Technical Bulletin

B9512G / B8512G Authority Level Names incorrect

- ▶ RPS / RPS-LITE v6.00, v6.01, v6.02
- ▶ B9512G, B8512G control panels

March 2, 2016

Figure 1: Authority Level Name parameters, RPS v6.00

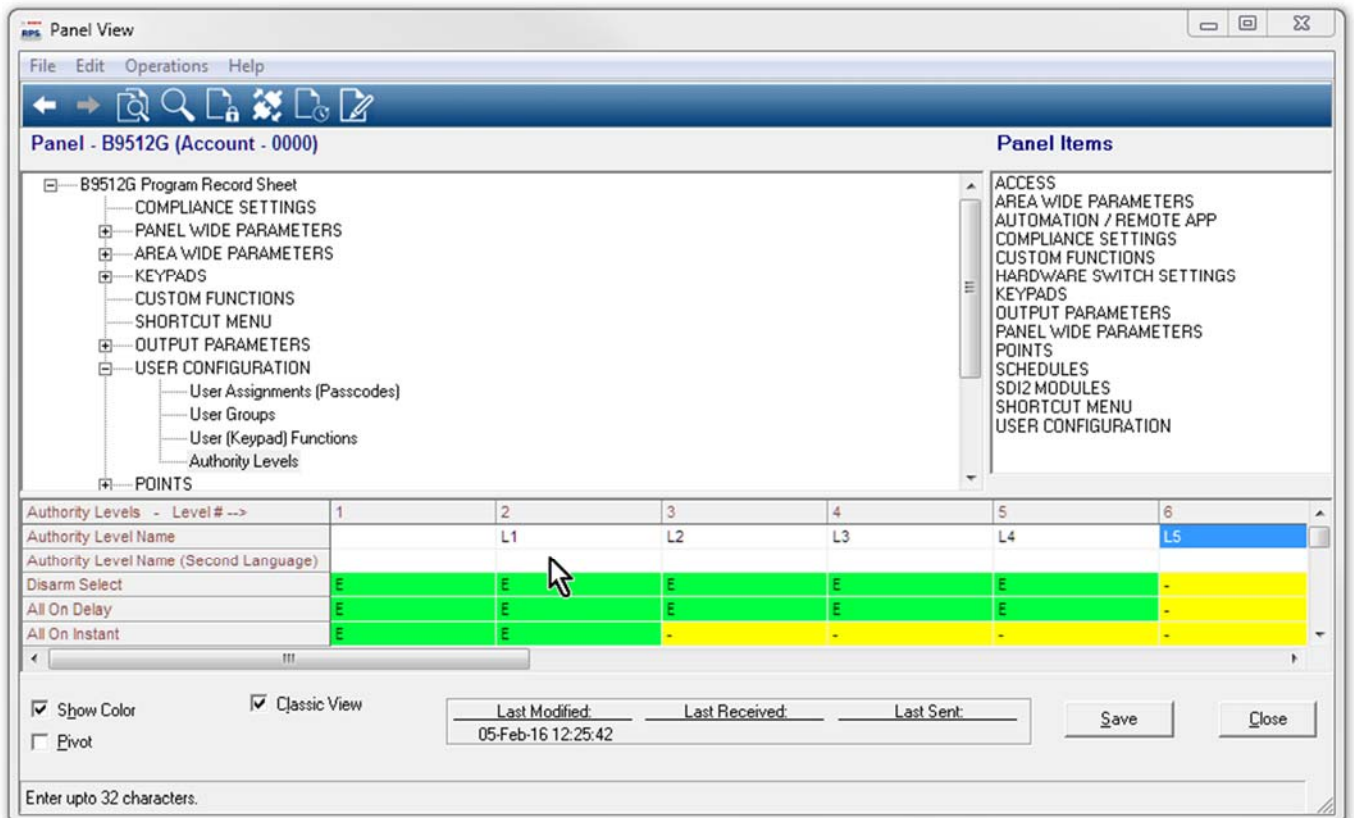
Issue 1: With RPS v6.00, the Authority Level Name parameters are incorrect for B9512G or B8512G control panel accounts for control panels with firmware v3.01 or v3.02.

The text for Authority Level 1 is shifted to Authority Level 2, the text for level 2 is shifted to level 3, and so on. The Authority Level Name for Authority Level 1 is blank.

B9512G or B8512G control panels with firmware v3.01 require RPS v6.01 to configure all of the features available in the firmware. Control panels with firmware v3.02 require RPS v6.02.

Update RPS from v6.00 to v6.02 to fully support control panels with either firmware v3.01 or v3.02.

Figure 2: Authority Level Name parameters, RPS v6.02

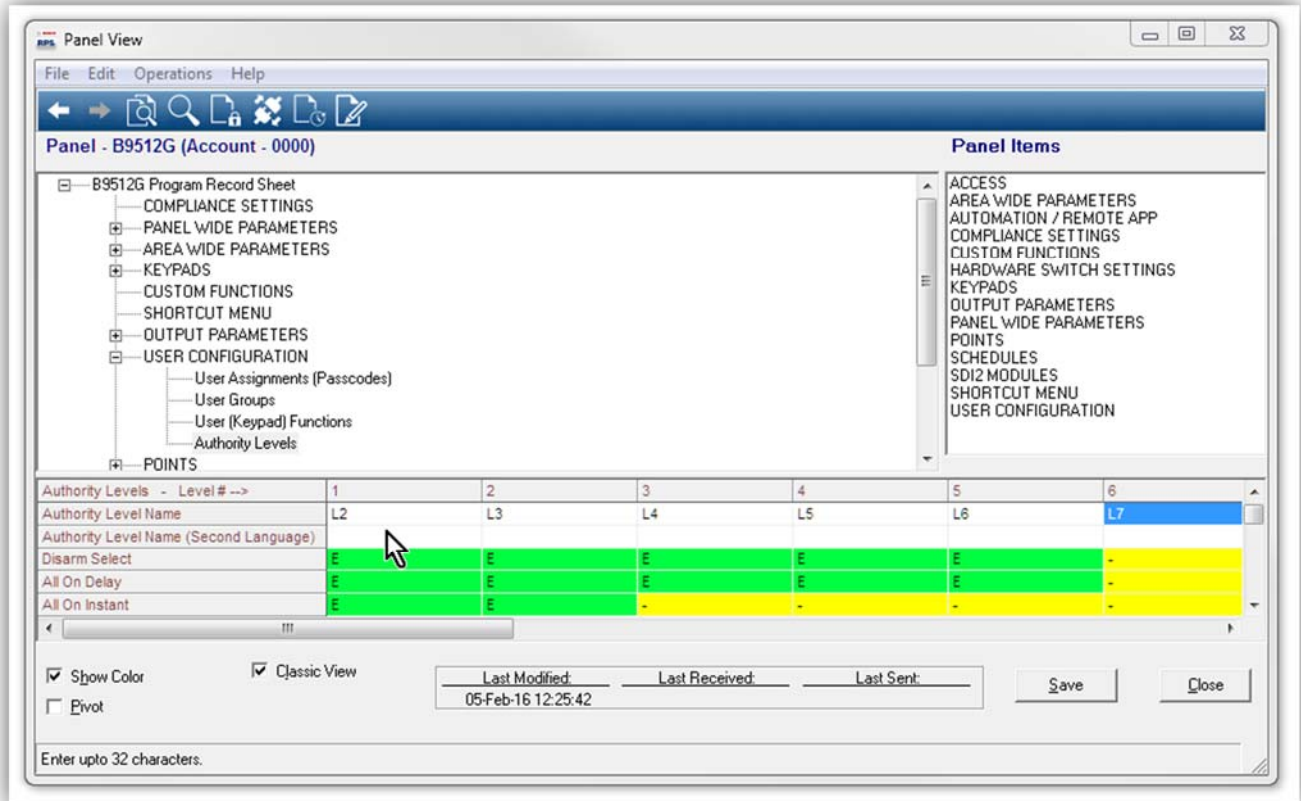
Issue 2: With RPS v6.01 or v6.02, the Authority Level Name parameters are incorrect for B9512G or B8512G control panel accounts for control panels with firmware v3.00.

The text for Authority Level 2 is shifted to Authority Level 1, the text for level 3 is shifted to level 2, and so on. The Authority Level Name for Authority Level 15 is blank.

The shift of Authority Level Names also occurs for B9512G or B8512G control panel accounts with firmware version 3.01 updated from firmware version 3.00.

There is no resolution for this Authority Level Name issue at this time.

Do not update control panel firmware from v3.00 to v3.01. Update from v3.00 to v3.02.

Important! When you update panel firmware from v3.00 to v3.02 be sure to receive the panel data from the control panel when you reconnect with RPS. Save the received panel data before you disconnect.

The workaround for the issue is:

1. Update RPS to v6.02.
2. For control panel accounts with firmware v3.00, update the control panel firmware to v3.02 and then receive and save the panel data from the control panel,
 - or –
 - manually correct the Authority Level Names.
3. For control panel accounts with firmware v3.01 that was updated from v3.00, manually correct the Authority Level Names.
